MFN 08-304

Docket No. 52-010

**Subject: Response to Portion of NRC Request for Additional Information Letter No. 85 Related to ESBWR Design Certification Application - Emergency Core Cooling Systems - RAI Number 6.3-64 S01**

**RAI Number 6.3-64 S01**

**Figure 6.3-64 S01-1. GDCS Line Break (Bounding Case) – Chimney Collapsed Level (72 hours)**

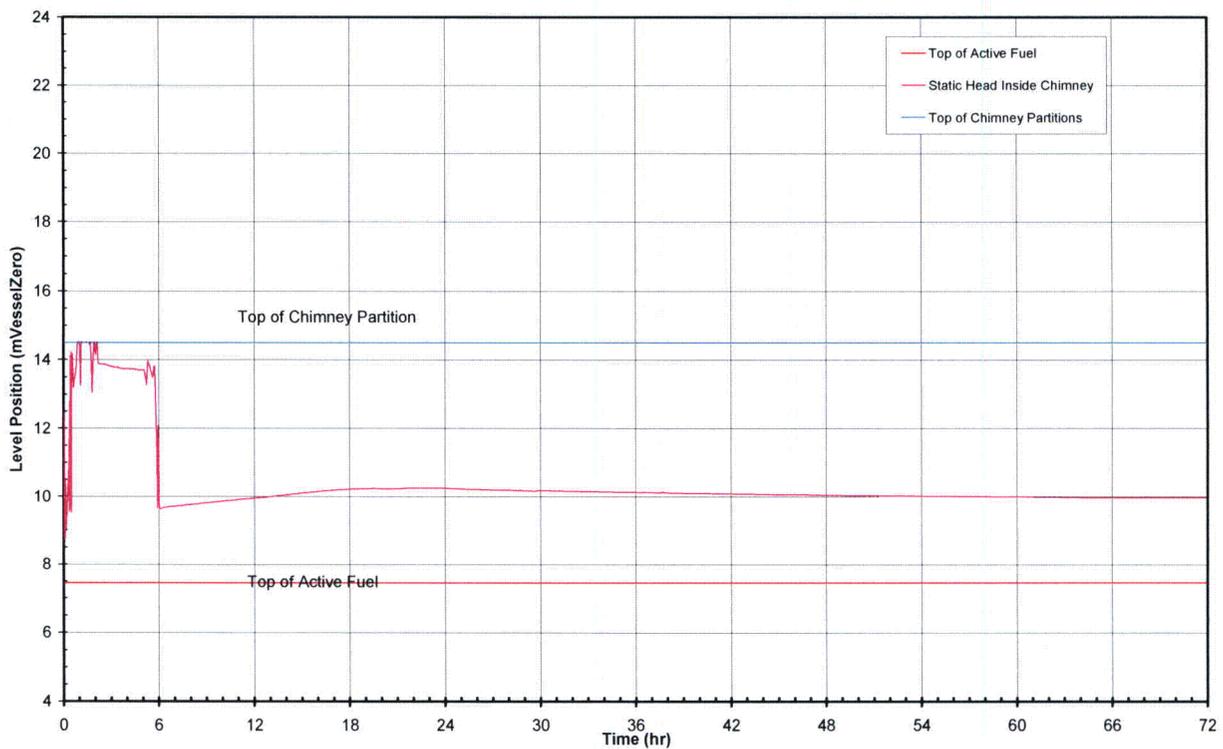
Staff requested that the applicant demonstrate the core remains covered for 72 hours for the limiting break. GE's response infers (it was not directly stated) that TRACG predicted the most limiting break for long term cooling is a GDCS line break with 1 DPV failure.

DCD, Section 6.3.3.7.9, with results displayed in Table 6.3-5, states that "the GDCS injection line break with a GDCS injection valve failure results in the lowest minimum chimney static head above vessel zero." Thus, the Staff would have expected that the RAI response provided plots of this limiting break. GE provided no explanation in the RAI response.

- A. Explain how GE came to the conclusion that the GDCS injection line break with 1 DPV failure (nominal case) is the most limiting break given the information provided in Table 6.3-5. Staff is also unclear why GE provided a plot of the nominal conditions rather than the bounding conditions for the GDCS Line break with 1 DPV failure. Include the appropriate information in the DCD.

- A. The Gravity-Driven Cooling System (GDCCS) injection line break with one depressurization valve (DPV) failure (nominal case) is not considered the most limiting break with regard to level. However, it is the most limiting GDCCS injection line break with regard to containment pressure response. For this reason, a 72-hour case already exists because the particular single failure mode will mainly impact the short-term response, and does not have a significant effect on the long-term loss-of-coolant accident (LOCA) response as was described in the original response to this RAI. The TRACG prediction of the collapsed level in chimney for GDCCS line break with one GDCCS injection valve failure is shown in Figure 6.3-64 S01-1. The minimum level of 8.50 m occurs at 593 seconds.

**Figure 6.3-64 S01-2. GDCS Line Break (Bounding Case) –  
PCCS Heat Removal (72 hours)**

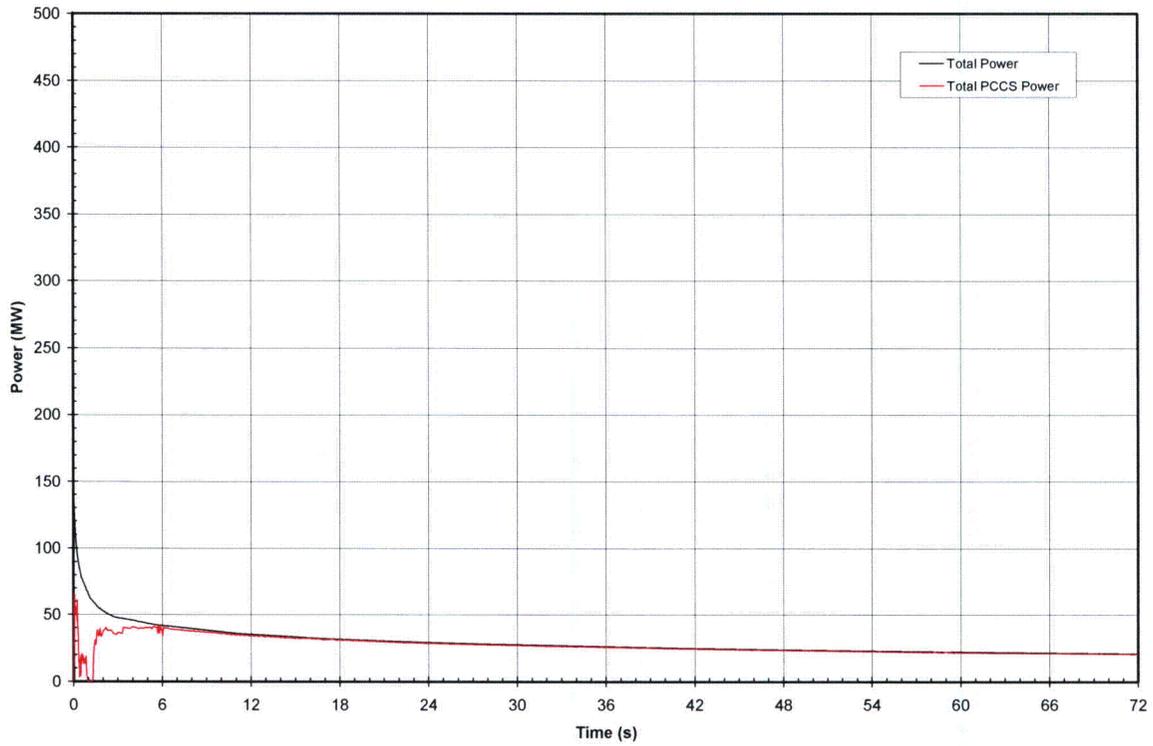
- B. Concerning the input deck assumptions, where are the non-condensable gases during the life of the transient? Staff is not convinced TRACG can accurately calculate the movement of non-condensable gases (reference RAI 21.6-96). Therefore, explain, and include in the DCD additional information regarding the treatment of non-condensable gases. Demonstrate that the treatment of non-condensable gases are conservative for long-term PCCS operation. Provide plots that show PCCS power versus time and, on the same plots, decay heat versus time.

- B. The discussion of the treatment of non-condensable gases in the analysis coverage was originally contained in the response to RAI 21.6-96 (MFN 07-348, dated June 21, 2007), and will be further clarified in the pending response to RAI 21.6-96 S01. Meanwhile, Figure 6.3-64 S01-2 contains the plot of Passive Containment Cooling System (PCCS) power versus decay heat for 72 hours from the current analysis.
